Our Ref: 22032

28 March 2022

**RE: 45 MOBBS LANE, CARLINGFORD
ASSESSMENT OF DRIVEWAY ISSUES**

Annexure B – Sight Distance Drawings

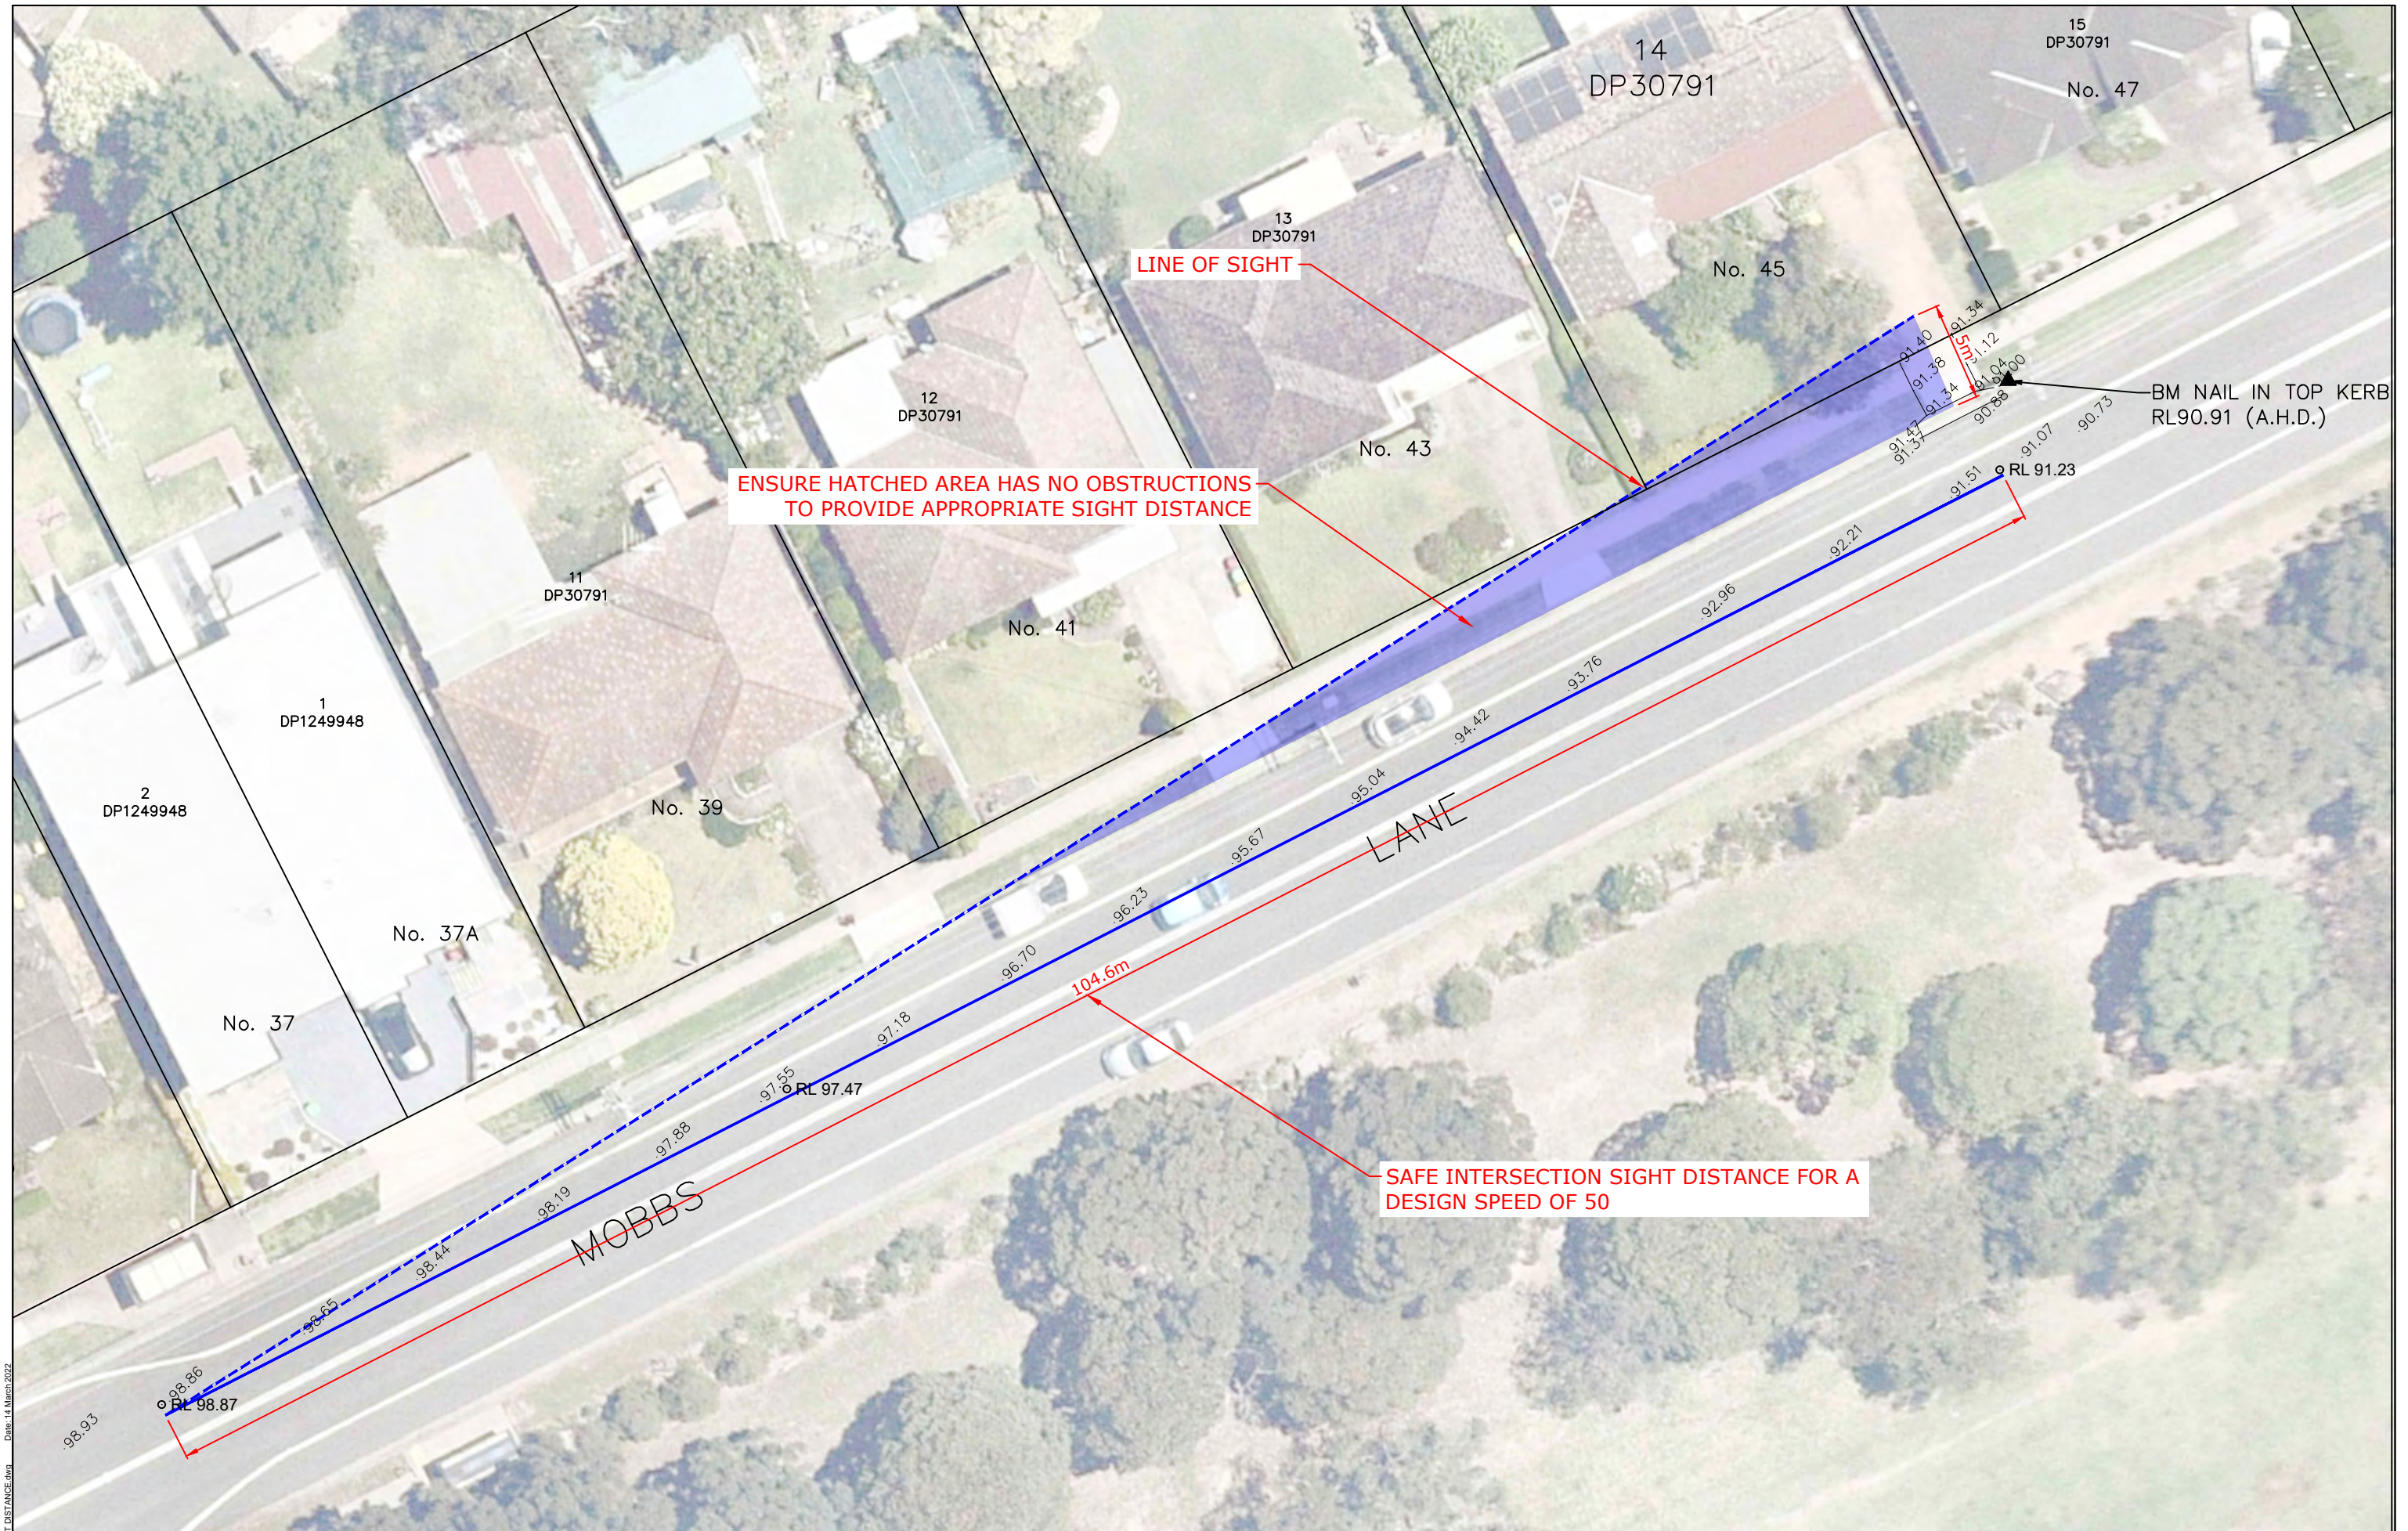
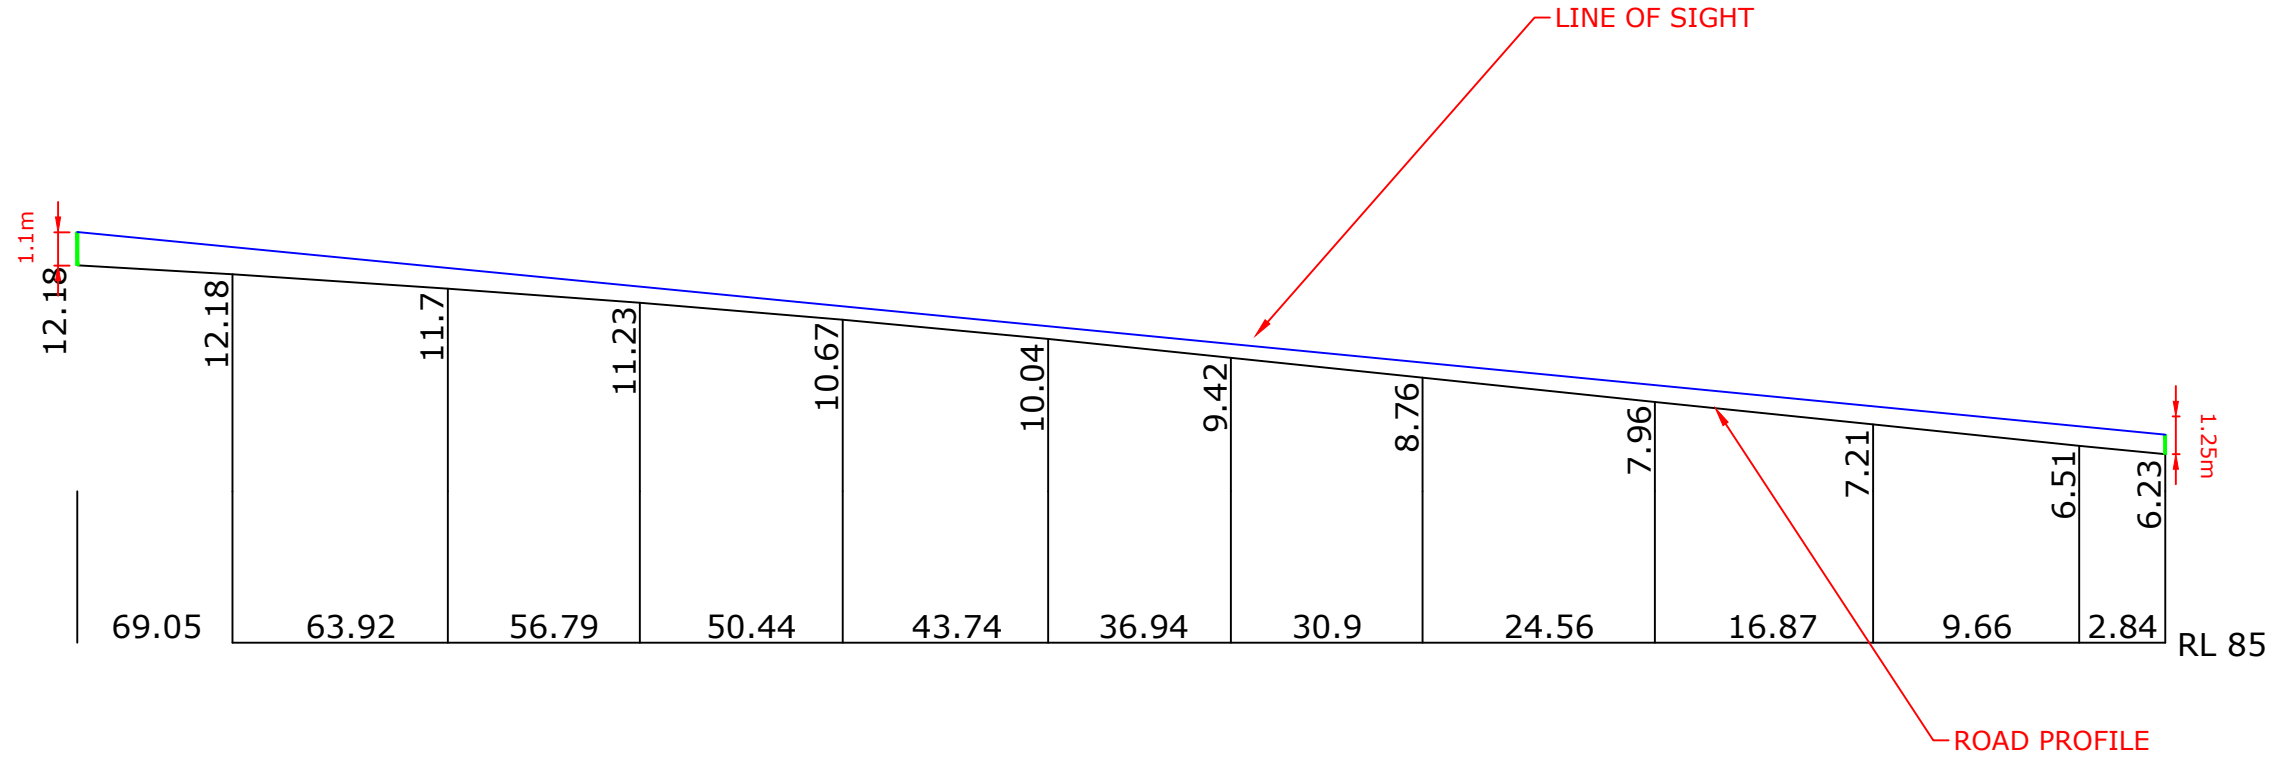
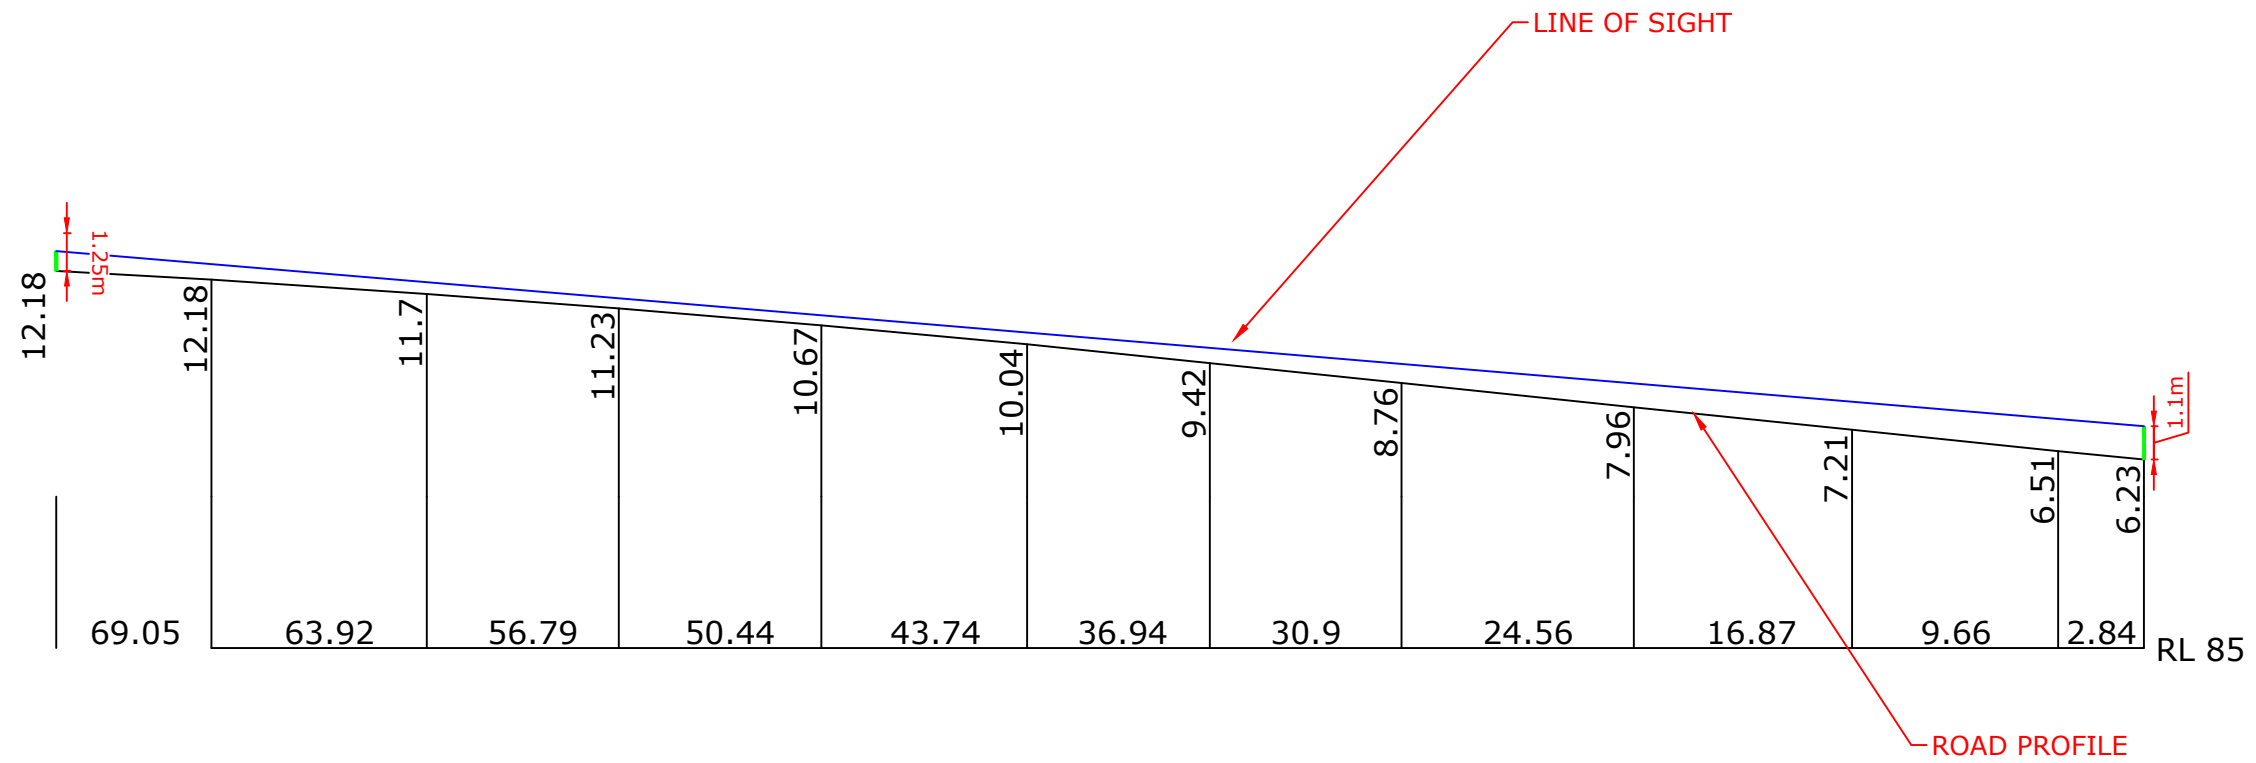
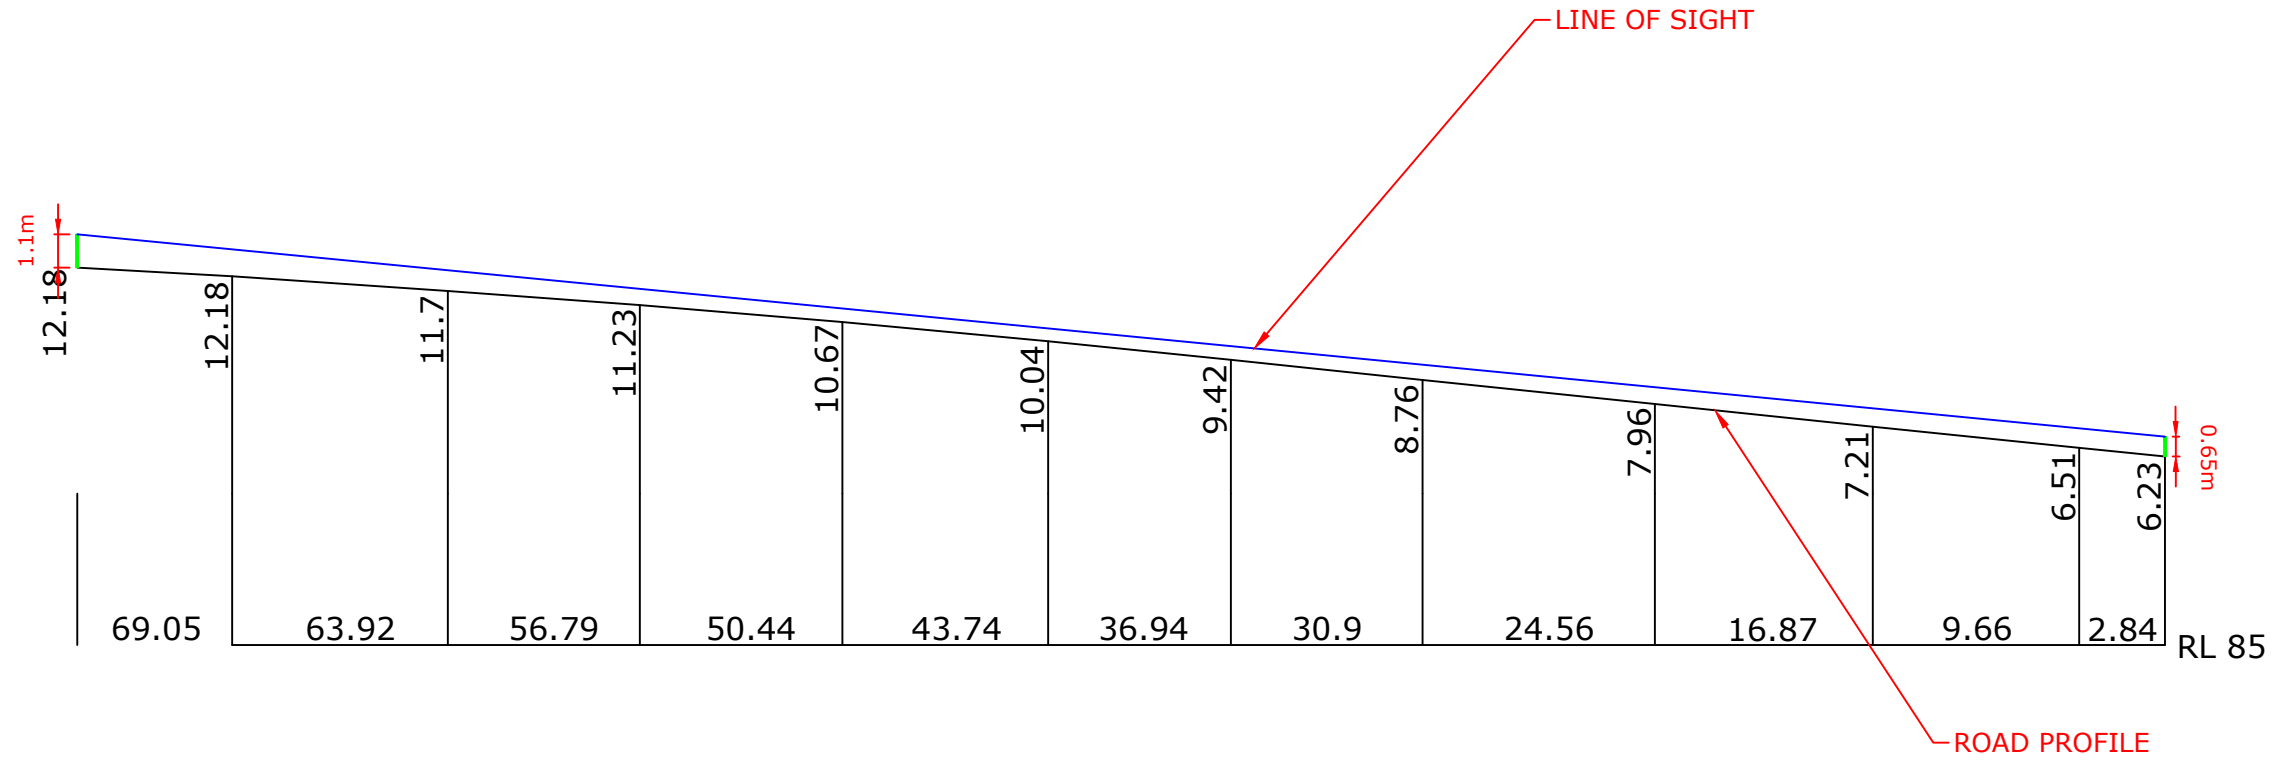
The analysis of these sight distances, contained at **Annexure B** confirms that the available AS2890.1 driveway sight distance and MGSD can be adequately provided but the SISD is marginally compromised by the profile of the road.
